Re: Incorrect Thermal broken Aluminum Joinery: 2 Rapare St. Job No.27363 - JSR Construction.

Subject: Re: Incorrect Thermal broken Aluminum Joinery: 2 Rapare St. Job No.27363 - JSR Construction.

Thank you for your kind help.	
Nga mihi,	
Harry	
Photo 1: Path of thermal conduction at the joint of window transom and sliding-door fixed in	terlocker and the same photo without marking is given side by side for easy reference

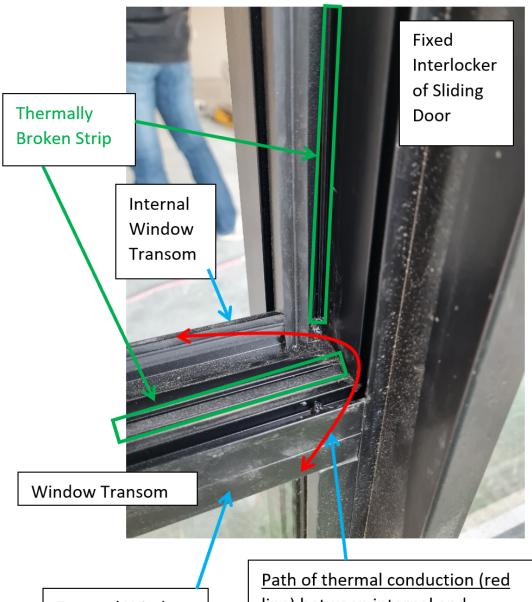
7/22, 6:27 PM	Gmail - Re: Incorrect Thermal broken Aluminum Joinery: 2 Rapare St. Job No.27363 - JSR Construction.
Kia ora Ricky,	
Thank you for your updated information.	
Would you provide us with a full warranty of the thermally broken sliding doors and windows	after the replacements of any components of the sliding doors and windows?
In short, you are required to at least but not limited to replace the fixed interlocker and stiles	with full warranty of the entire products. The details are given below.
You shall provide us with the following:	
indicated by the red line on the marked photo as shown on Photo 1 below. The same thermal image (see Photo 2) with the sunshine reaching half the height of the sliding thermally-broken members (e.g. bottom of the sliding door frames and the window tr.	er the replacement. Hagley Windows & Doors mentioned that, on their email, they will not provide us with the warranty of the sliding doors if they change the stiles of the sliding doors (refer to the part is highlighted

line) between internal and external parts of the window transom via the fixed interlocker Photo 2: Thermal image of the sliding door and window with the sunshine reaching half the height of the sliding door. It showed that the non-thermally broken components (the joint in between the interlocker and the window transom, and the stile) creating a thermal conduction between the internal and external parts of the thermally-broken members (e.g. bottom of the sliding door frames and the window transom).

I have mentioned this to Ricky but just wanted to email to confirm that we have agreed to replace the non-thermal extrusions for you.

I can also confirm that the fixed interlocker has already been supplied as a thermally broken extrusion so this will not be changing, there is no other extrusion or alternative here that could be put in its place and APL have only the one thermally broken fixed interlocker which I can confidently say has been installed as you have pointed out in your photo.
